Access Compliance Report

Public Rights-of-Way

Intersection ID: 48139	Main Street: BEATY_CALDWELL_LN	Cross Street: WEDDINGTON_RD	Location: NE
ADA ID: 4B9F609C13B9	Ramp Type: BlendTrans1	Initial Pass/Fail: Fail	Overall Compliance: No
		Severity Score: 10

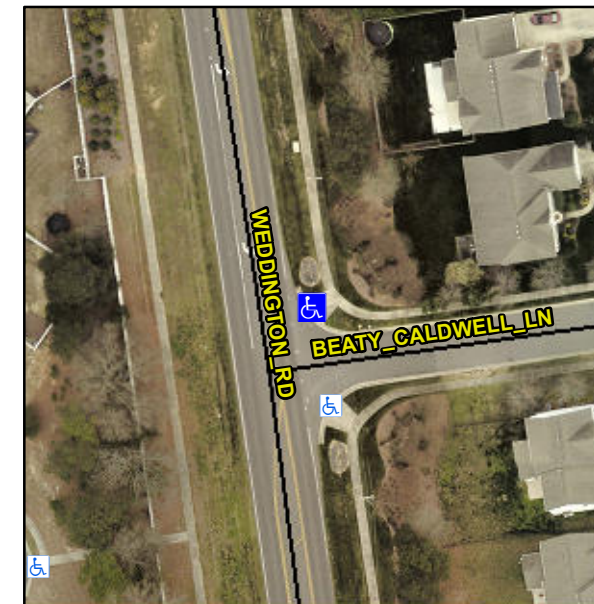
Not Found, R304.5.1, R304.5.3

Compliance	Description	Data	Compliance	Description	Data
N/A	Ramp Length (in)	145.0	Yes	BlendTrans Slope (%)	4.6
No	Ramp Width (in)	47.5	No	BlendTrans XSlope (%)	2.3
N/A	Flare Type LT	N/A	N/A	Flare Type RT	N/A
N/A	Flare Slope LT (%)	N/A	N/A	Flare Slope RT (%)	N/A
N/A	Flare Traversable LT?	N/A	N/A	Flare Traversable RT?	N/A
N/A	Landing Length (in)	N/A	N/A	DWS Provided?	N/A
N/A	Landing Width (in)	N/A	N/A	DWS Contrast?	N/A
N/A	Landing Slope (%)	N/A	N/A	DWS Length (in)	N/A
N/A	Landing X Slope (%)	N/A	N/A	DWS Full Width?	N/A
N/A	Landing Curb? (Y/N)	N/A	N/A	DWS Offset (in)	N/A
N/A	Shared Landing?	N/A			
N/A	Gutter Ponding?	N/A	N/A	Gutter Slope (%)	N/A
N/A	Gutter Lip Ht (in)	N/A	N/A	Gutter X Slope (%)	N/A
N/A	Painted X Walk1?	No	N/A	Painted X Walk2?	N/A
	X Walk 1 Direction	To S		X Walk 2 Direction	N/A
	X Walk 1 Width (in)	N/A		X Walk 2 Width (in)	N/A
	X Walk 1 Slope (%)	1.6		X Walk 2 Slope (%)	N/A
	X Walk 1 X Slope (%)	2.1		X Walk 2 X Slope (%)	N/A

N/A	Ramp inside XWalk1?	N/A	N/A	Ramp inside XWalk2?	N/A
	Road Slope (%)	2.1		Clear Space?	N/A
	Road X Slope (%)	1.6	N/A	Clear Space to XWalk (in)	N/A
N/A	Any Obstructions?	N/A	N/A	Storm Grate/Utility Hazard?	N/A
	Obstruction Type			Storm Grate/Utility Type	
		N/A			N/A
			Yes	Surface Condition? (G/P)	Good
			No	Curb Slope (%)	14.3

Remove & Replace Curb Ramp With Two New Directional Ramps or Equivalent.
